Well Name: ROSS DRAW UNIT	Well Location: T26S / R30E / SEC 27 / SWSE / 32.00767 / -103.86582	County or Parish/State: EDDY / NM
Well Number: 60	Type of Well: OIL WELL	Allottee or Tribe Name:
Lease Number: NMNM11042	Unit or CA Name: ROSS DRAW - DELAWARE	Unit or CA Number: NMNM71027A
US Well Number: 3001541979	Operator: WPX ENERGY PERMIAN LLC

Notice of Intent

Type of Action: Plug and Abandonment

WELLBORE DIAGRAM - PROPOSED

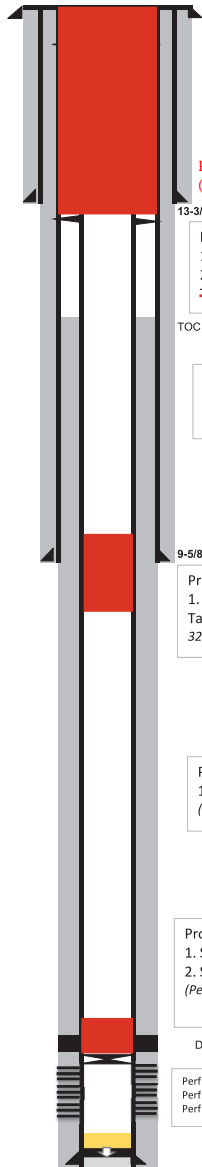
REVISED

Perf and squeeze from 912' to surface.
(In 91 sxs/Out 177 sxs) Class C.

Proposed:
1. Perf @ 912'
2. Sqs ~~50 sxs Cl C from 912'-770' WOC & Tag~~ (Shoe @ 855', Rustler @ 862')

Proposed:
1. Spot 25 sx Cl C from 1639'-1430'.
(Castile @ 1589')

Proposed:
1. Spot ~~40~~ sx Cl C from ~~3490'-3170'~~ WOC & Tag (Delaware @ 3446', Shoe @ 3412', B. Salt @ 3250')

Spot cement from 3496' to 2845'. 65 sacks Class C.

Proposed:
1. Spot 25 sx Cl C from 4610'-4400'.
(Cherry Canyon @ 4560')

Proposed:
1. Set CIBP @ ~~5550'~~. Tag. Pressure test 500 psi/ 30min.
2. Spot 25 sx Cl C from ~~5550'~~-5340'. WOC & Tag
(Perfs @ 5576', DV Tool @ 5530, Brushy Canyon @ 5528')

Set at 5526'
